Rezoning Application: PD 26-0555 Rev

**Hillsborough
County Florida**

Development Services Department

APPLICATION NUMBER: PD 26-0555

8.0 PROPOSED SITE PLAN (FULL) Page 2

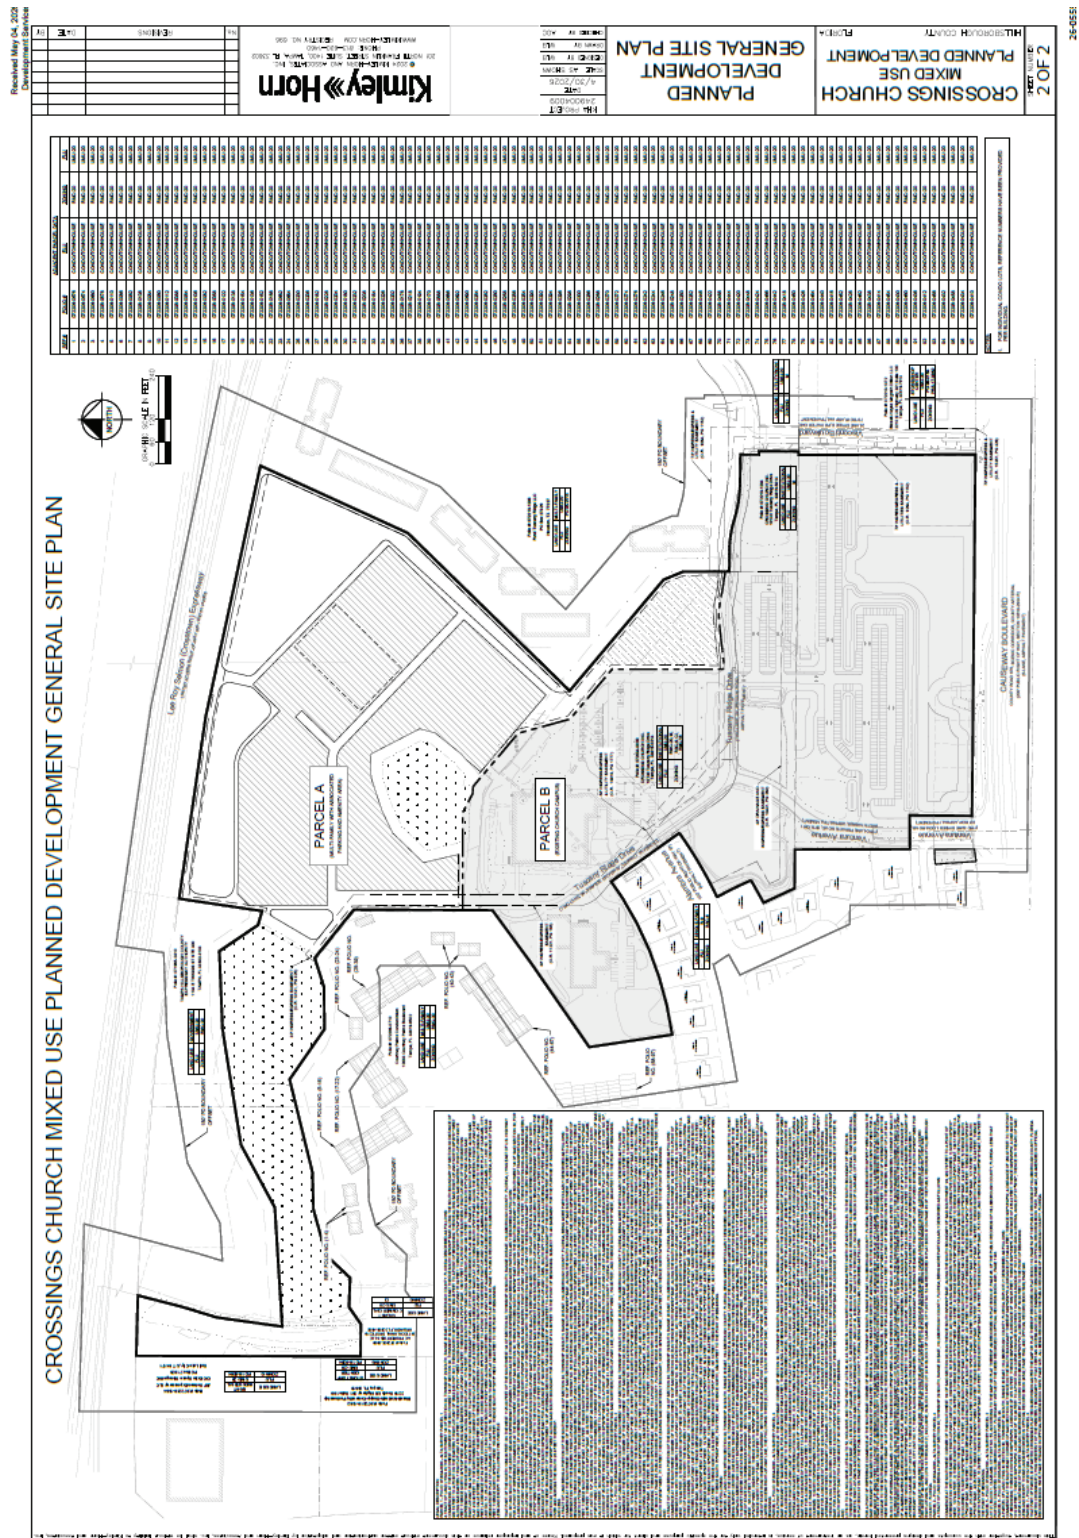
1. Revise "Front Crosstown Expressway" to "Rear Crosstown Expressway"
2. Prior to Certification, the applicant shall revise the PD plan sheet note #6 to state "Final design and location of the sidewalk connection to Visconti Boulevard shall be determined at the time of site development review."
3. Revise "15' Building Setback" to "10' Building Setback" off Tuscany Ridge Road.

HILLSBOROUGH COUNTY
PLANNED DEVELOPMENT
CROSSINGS CHURCH
MIXED USE
GENERAL SITE PLAN

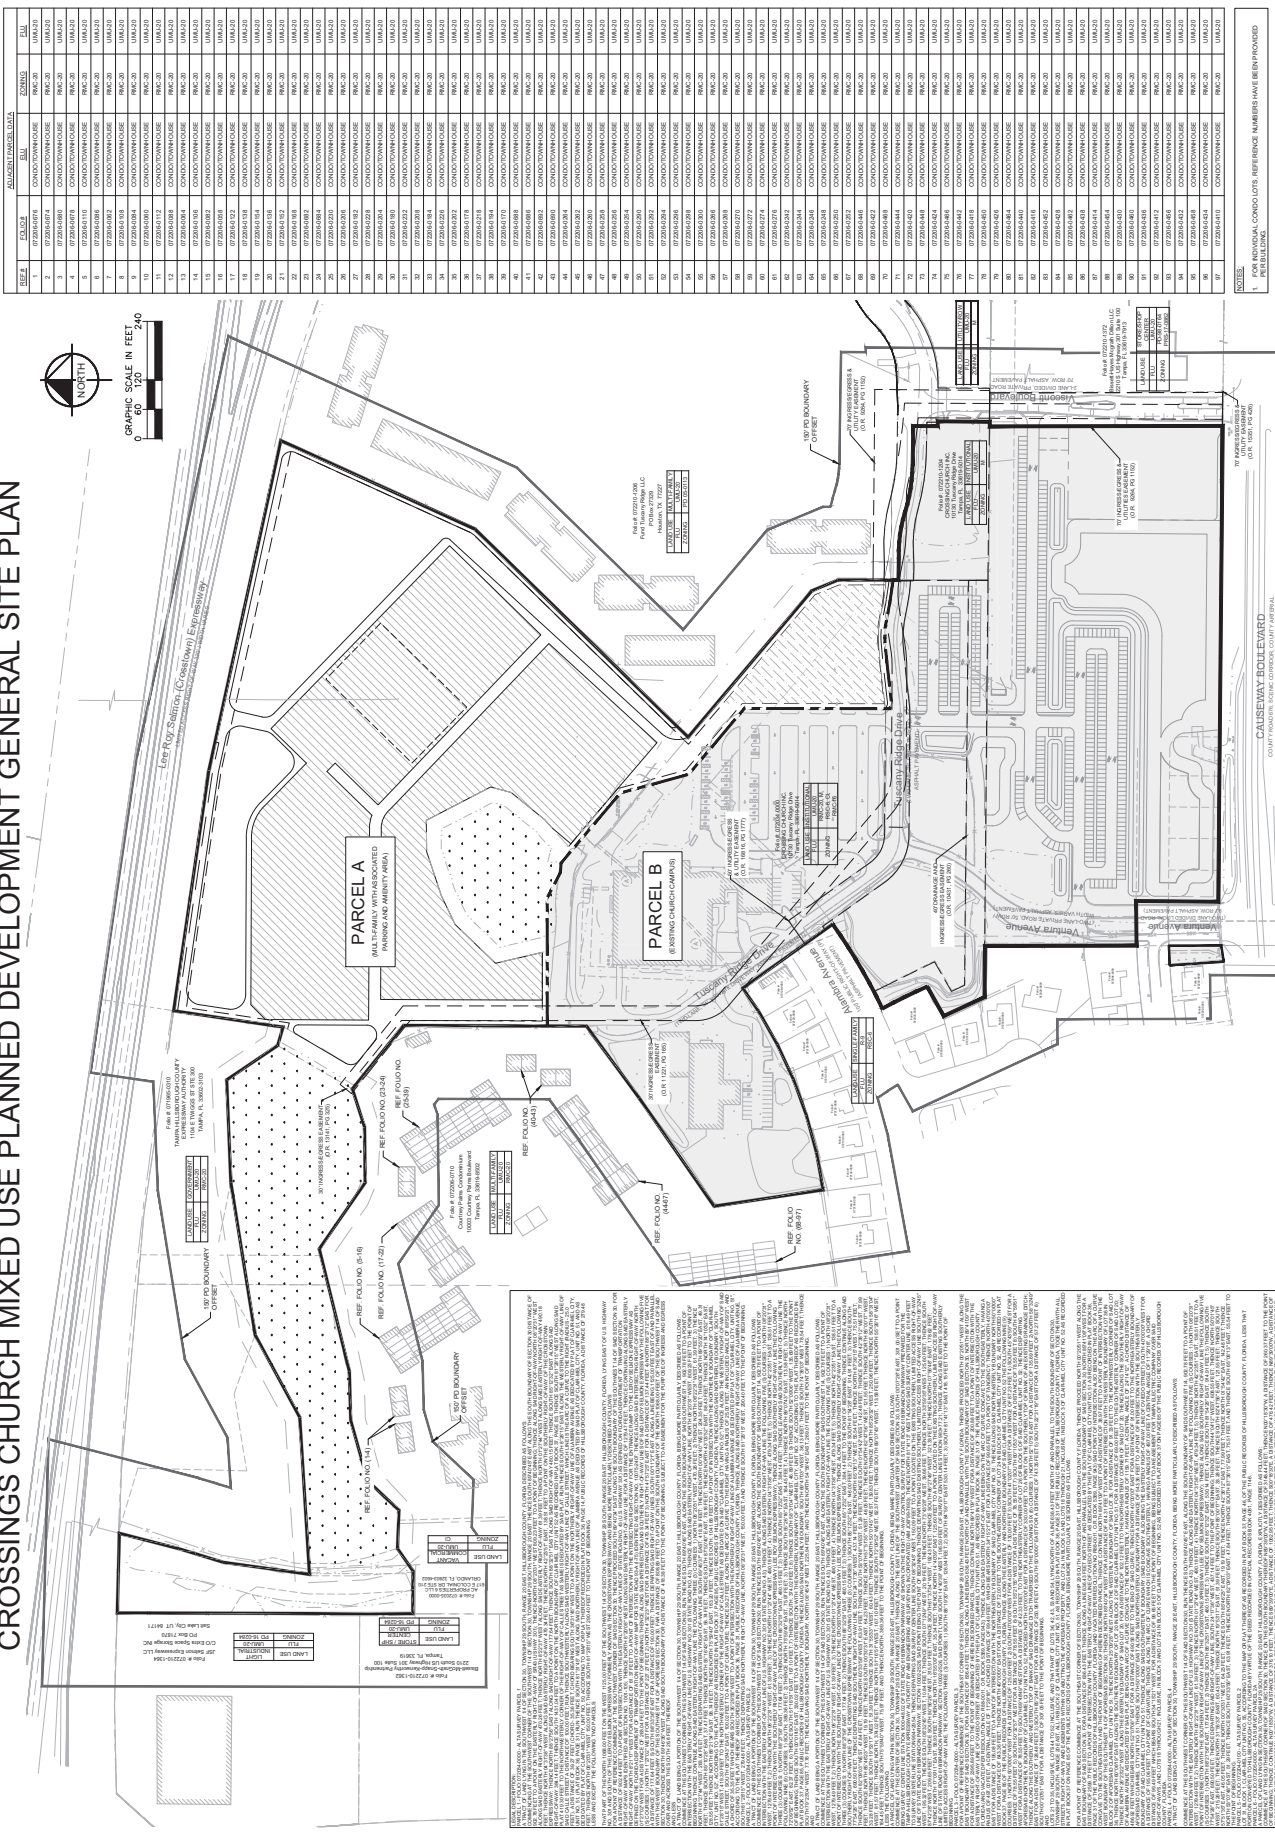
- Prior to Certification, the applicant shall revise the PD plan sheet note #6 to state “Final design and location of the sidewalk connection to Visconti Boulevard shall be determined at the time of site development review.”
